**The Great Grid Upgrade**

Sea Link

Document 9.153: Applicant's Response to the ExA's Rule 17 Letter

Planning Inspectorate Reference: EN020026

Creator: EB	Date: 28/04/2026	Checker: DF	Date: 28/04/2026	Approver: SE	Date: 28/04/2026
Document Ref: FIGURE 6.4.4.5.7	Scale: 1:6,500	Format: A3	Sheets: 1	Rev: 1

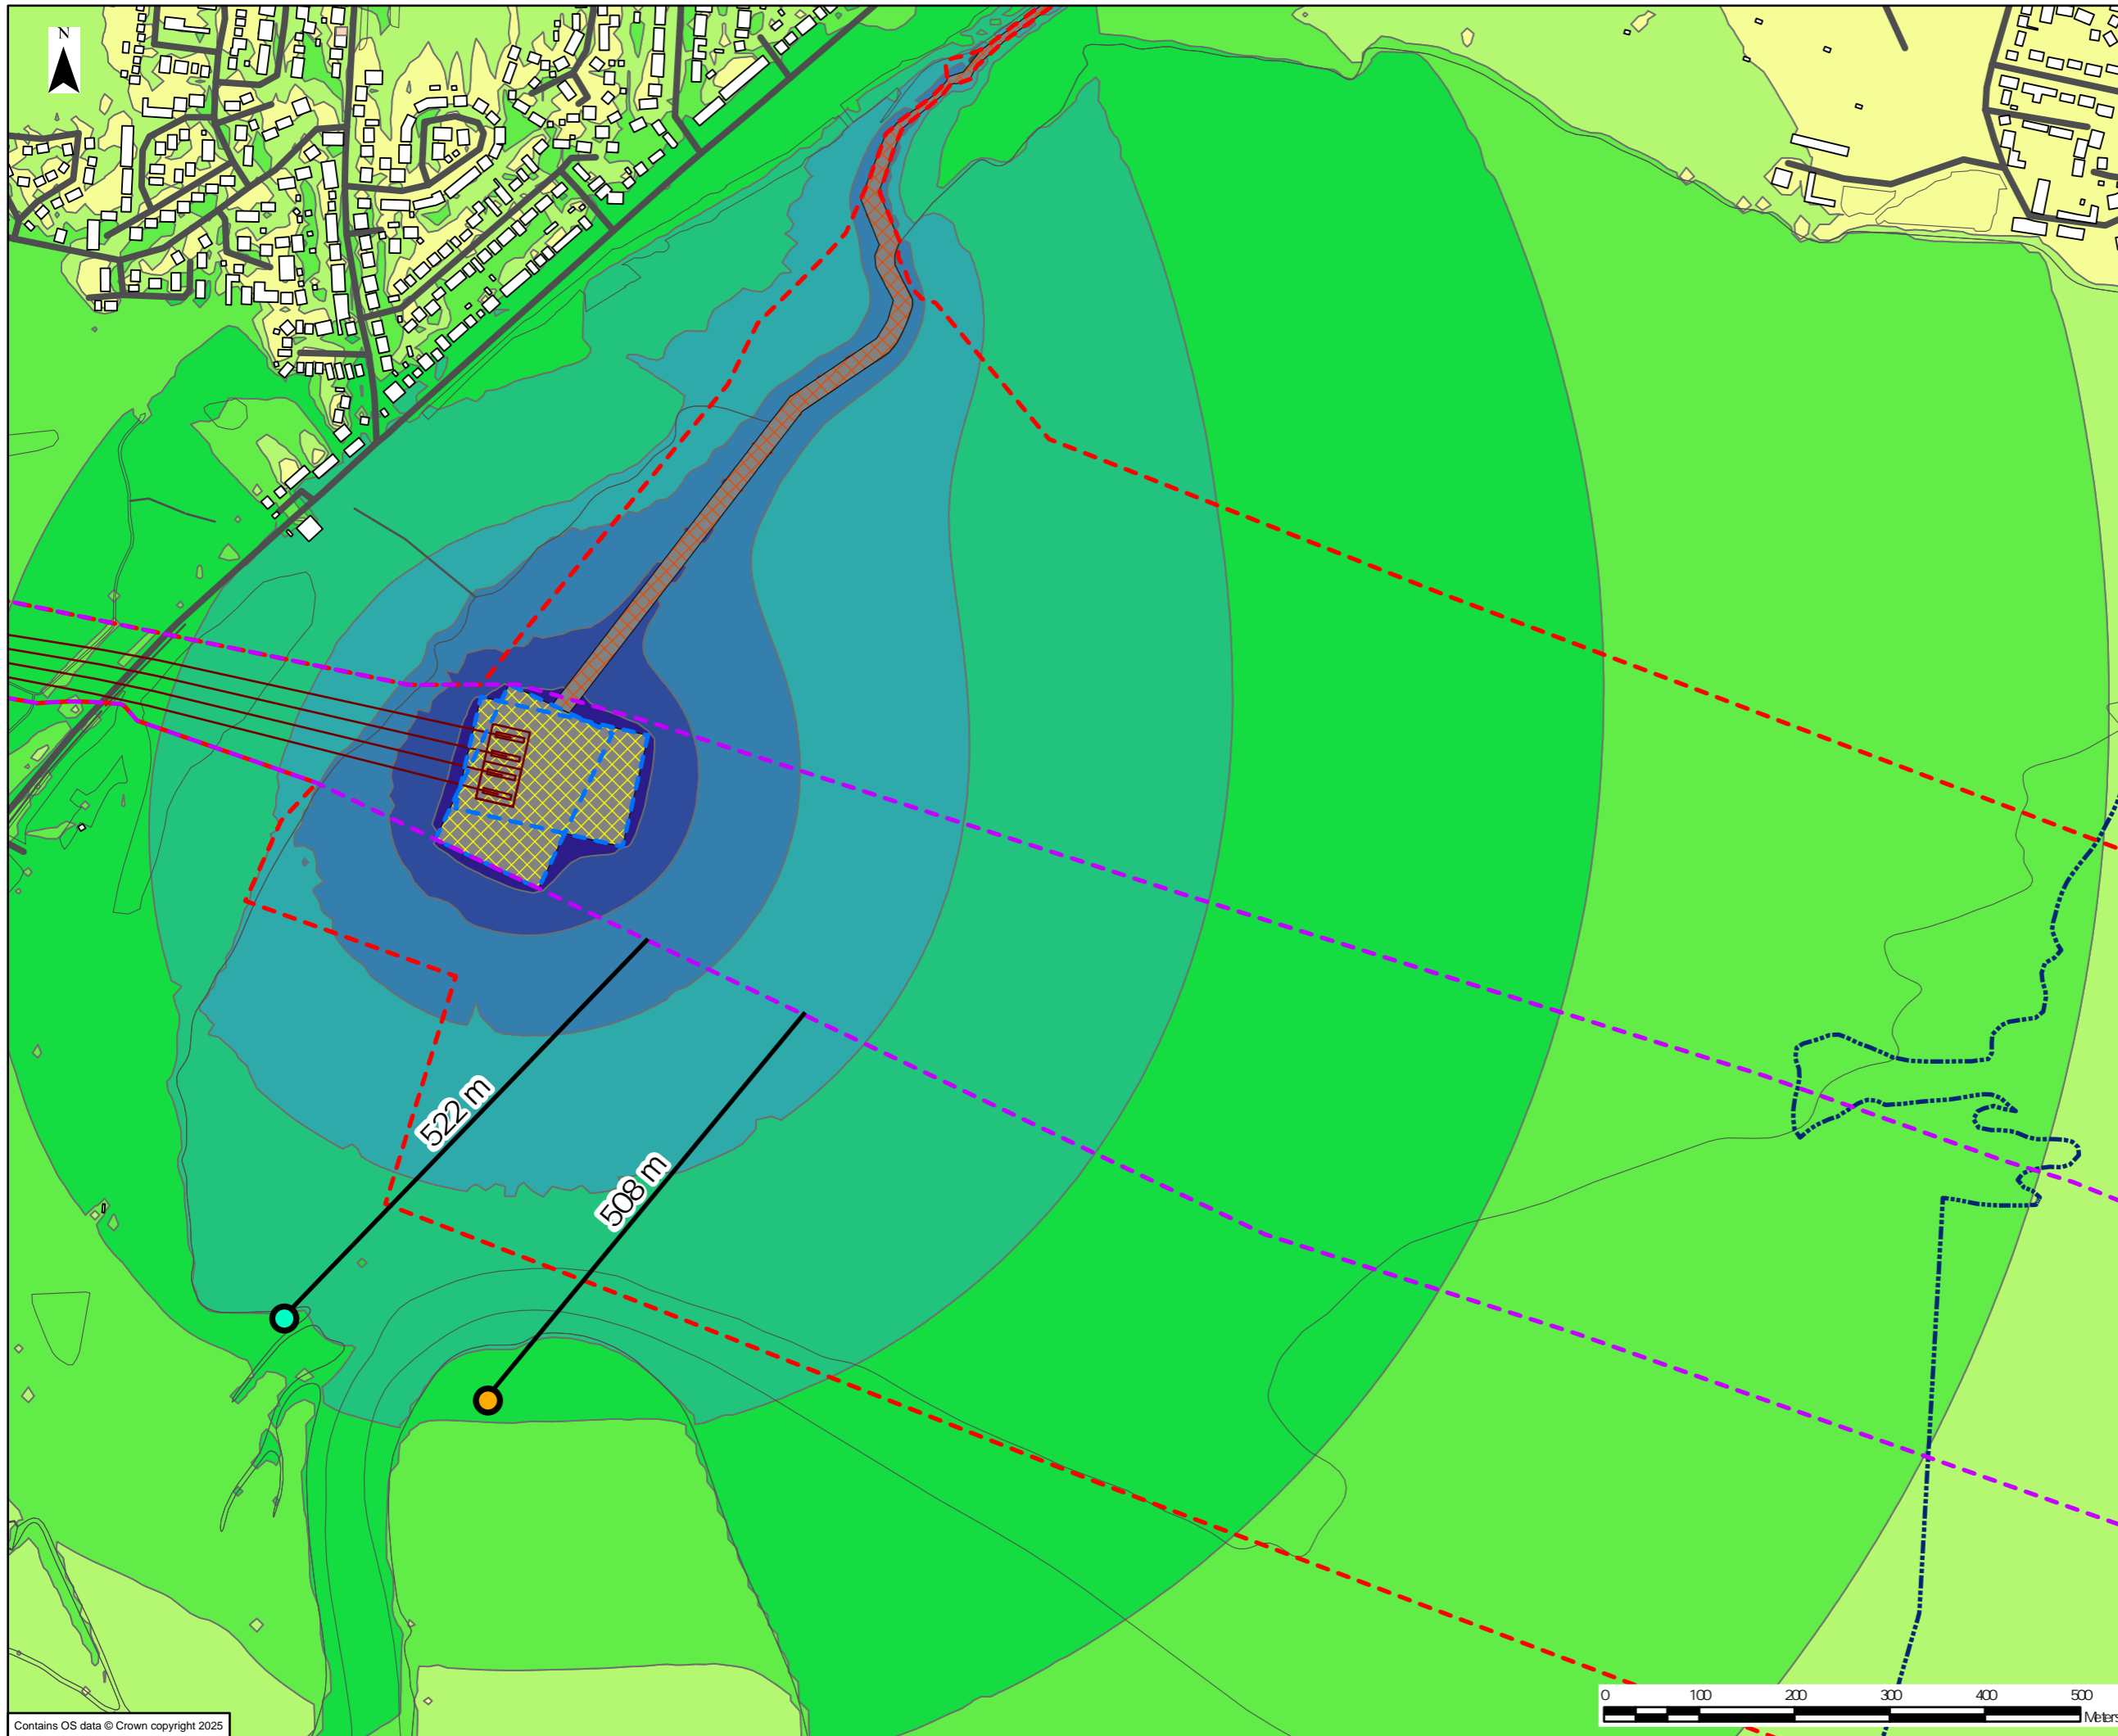
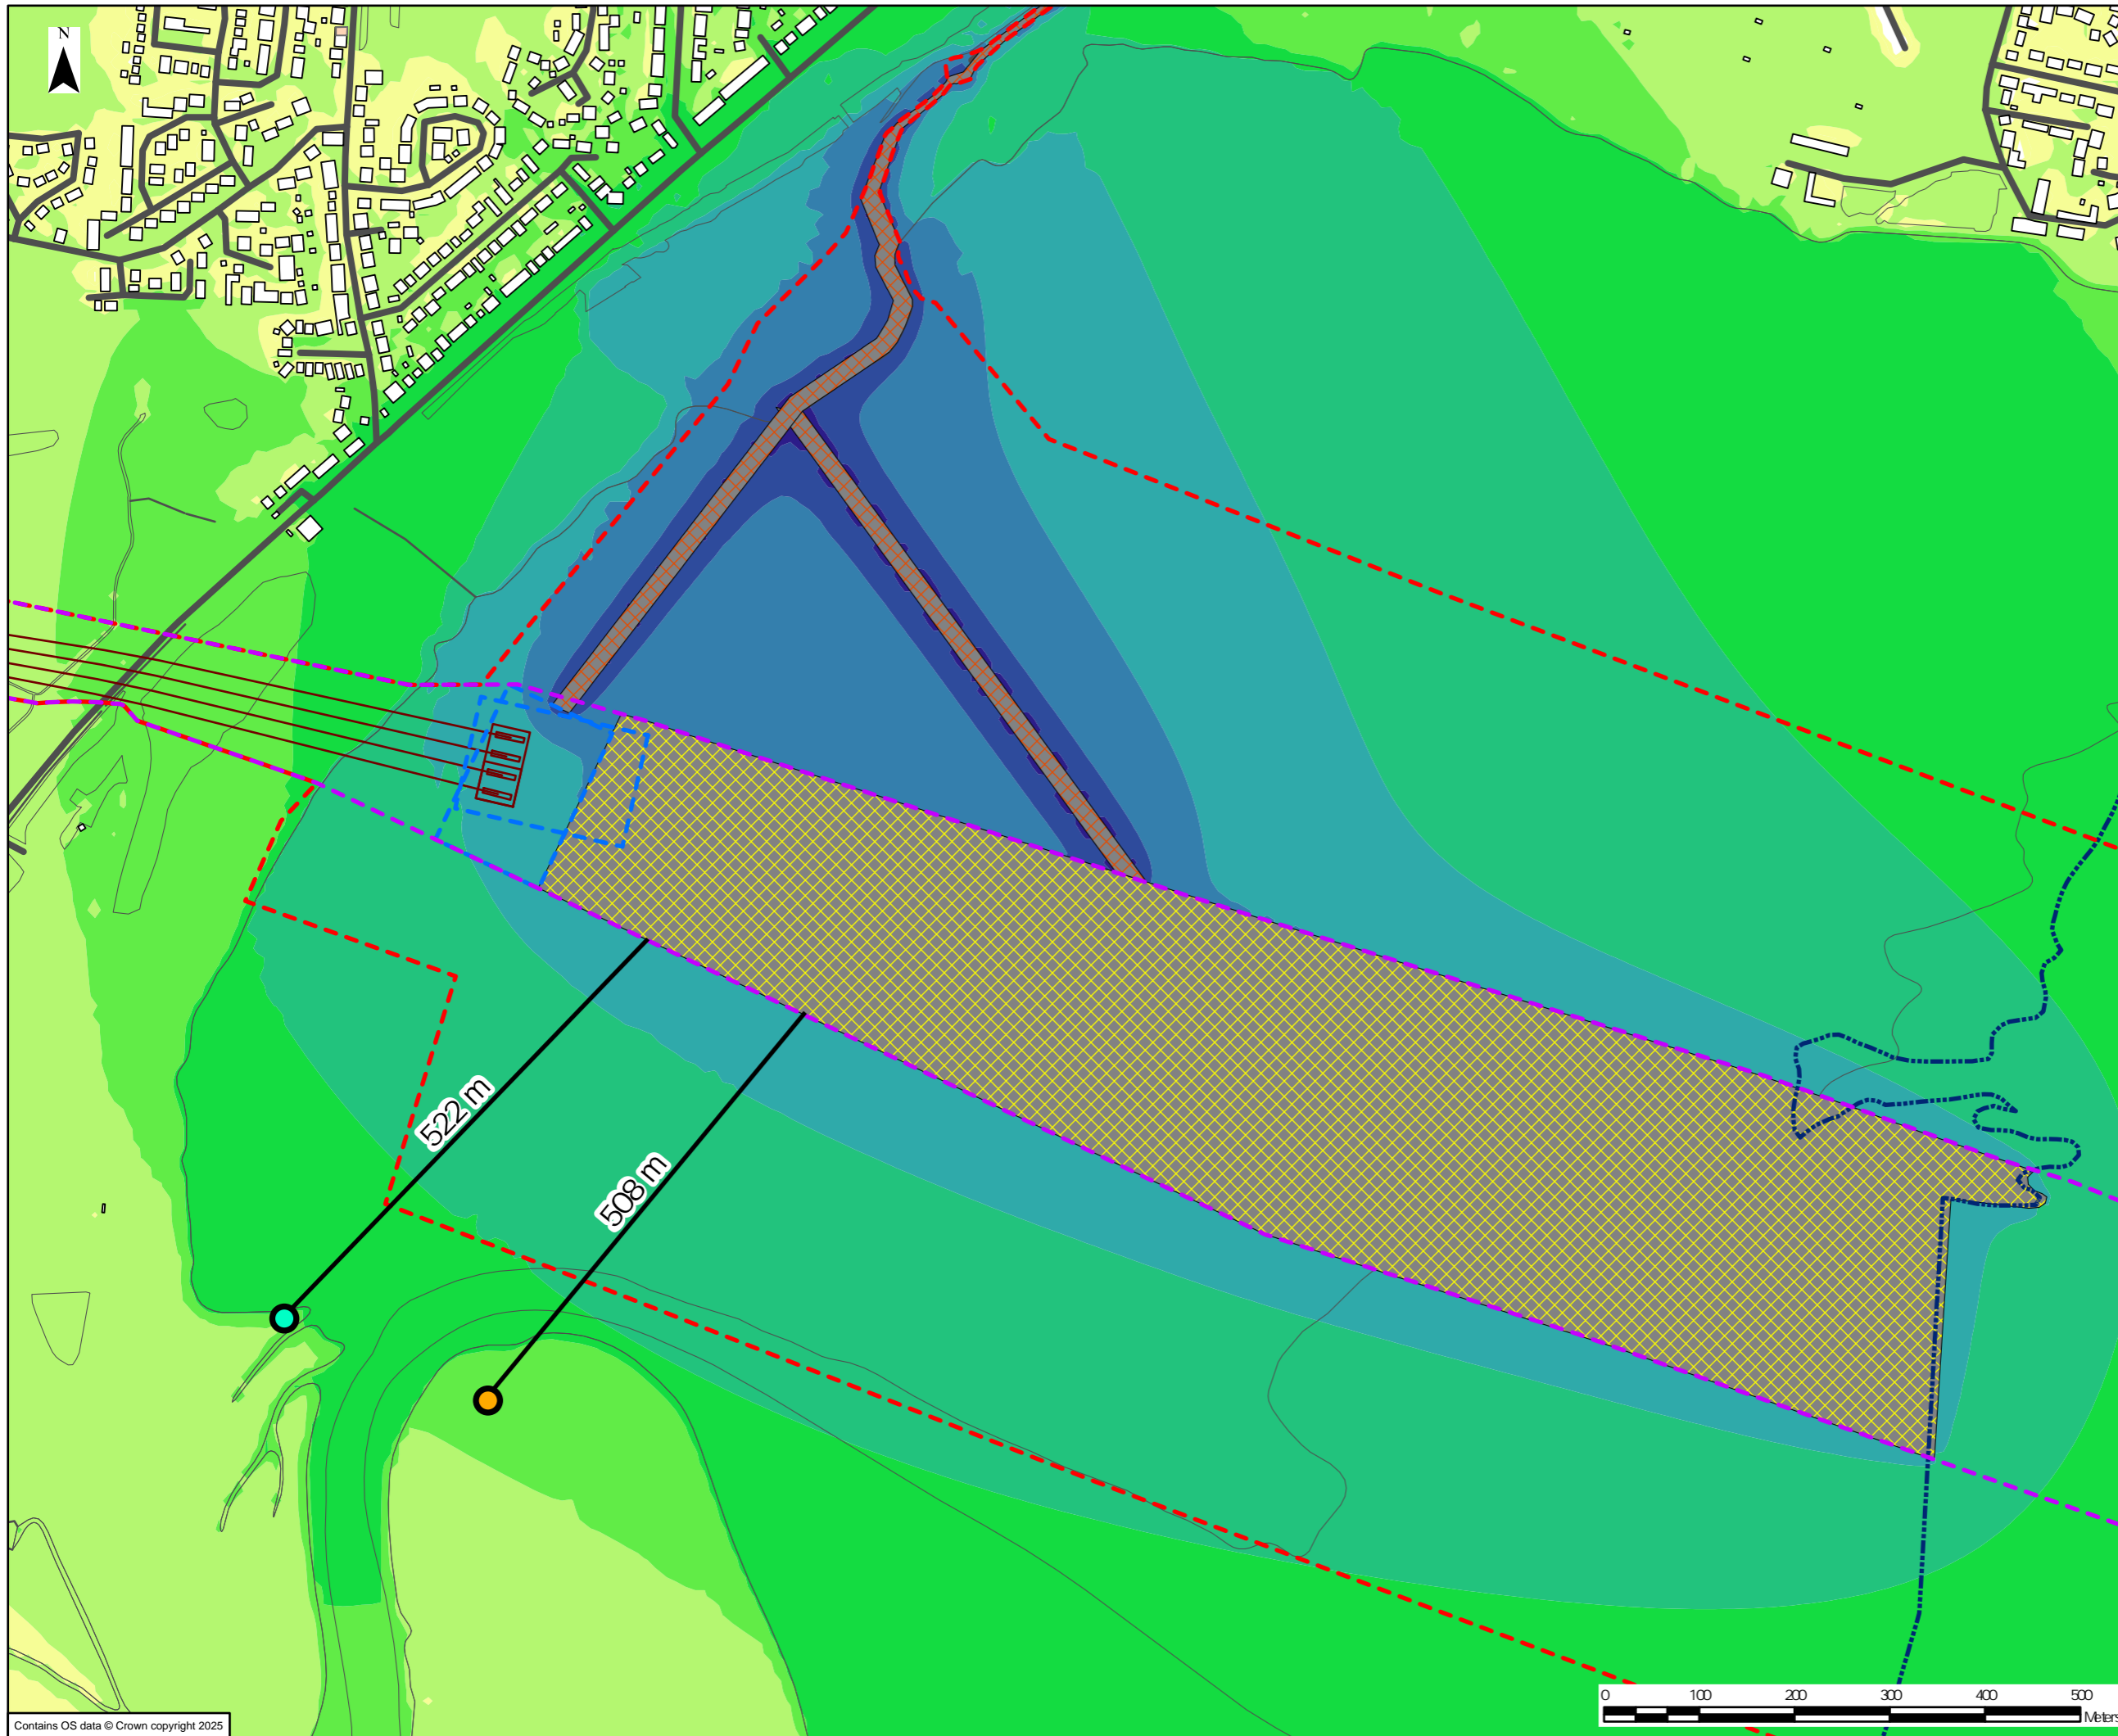
Reference	Question	Applicant's Comments
8.3	<p><u>8.3 Noise modelling – Pegwell Bay</u>  Applicant to provide updated marine ornithology predicted <math>L_{AFmax}</math> plans (figures 6.4.4.5.7 and 6.4.4.5.7) [REP5-032] showing the hoverport modelled as hard ground rather than soft ground. Any dependent assessments should be updated where relevant.</p>	<p>Notably, the predicted baseline noise levels at these receptors is calculated as 52.9 dB <math>L_{Aeq,8h}</math>. This comfortably sets the threshold for potential effects, using the BS 5228-1 (BSI, 2014) 'ABC' method, as Category C at these properties during night-time periods, with a threshold of 55 dB <math>L_{Aeq,8h}</math>. The assumed 45 dB <math>L_{Aeq,8h}</math> Category A threshold was therefore worst-case for these properties.</p> <p>Addressing the first point, therefore, assuming average spread over the 24 period (as per <b>9.148 Hoverport Construction Access Noise Modelling - Technical Note [REP6-123]</b>) the predicted noise level due to traffic on the access road was 44 dB <math>L_{Aeq,8h}</math>. Assuming, as a worst-case, all construction traffic occurred at night, noise levels would be approximately 5 dB higher, and therefore approximately 49 dB <math>L_{Aeq,8h}</math>.</p> <p>This level is comfortably below both the baseline noise level, and the associated threshold for potential significant adverse effects. As such, neither adverse nor significant adverse effects are expected from construction traffic on Sandwich Road, or on the Hoverport access road during either daytime or night-time periods.</p> <p>Addressing the third point, therefore, no mitigation is required.</p>

For the purpose of completeness the modelling assumes that the vehicles will gain access to the mudflats via the front edge of the hoverport (as included in the Order Limit change)
